**BURIED PLANT
TERMINATIONS OF BURIED WIRE
AT JUNCTIONS WITH BURIED PLANT**

1.001 This addendum supplements Section 629-720-205.

1.002 It is issued to introduce the C-4047 G Protector Clip for bonding buried service wire at the protector.

**Fig. 13.1
G. Protector Clip**

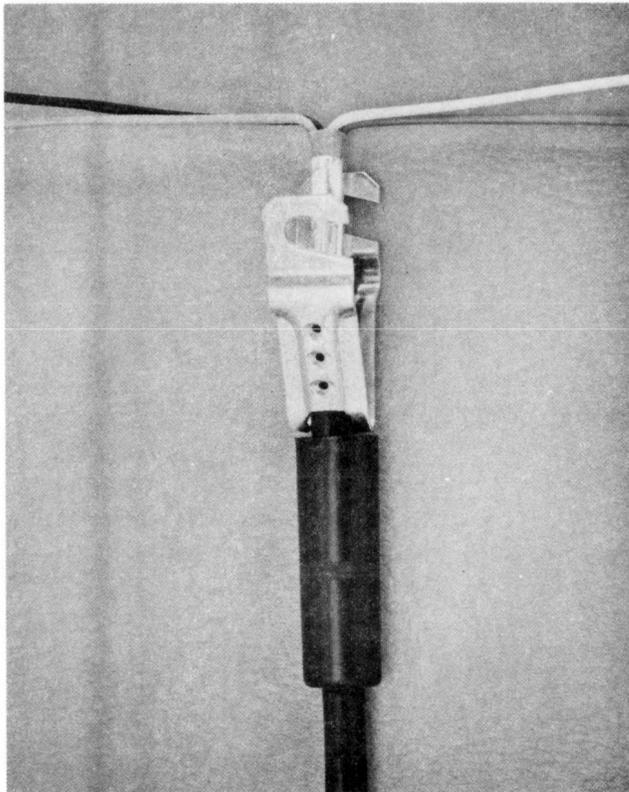
(c) Figures 13.1 and 14.1 — Added

5.01 The F Connector and the C-4047 G Protector Clip can be used to bond the metallic shield of service wire or the armor wire of underground wire to 123A1A, 123B1A, or 128A1A-2 protectors. Both devices have a spade-type tip which can be placed under the pronged washer of the protector ground terminal without removing the nut. Figures 13.1 and 14.1 illustrate the G Protector Clip.
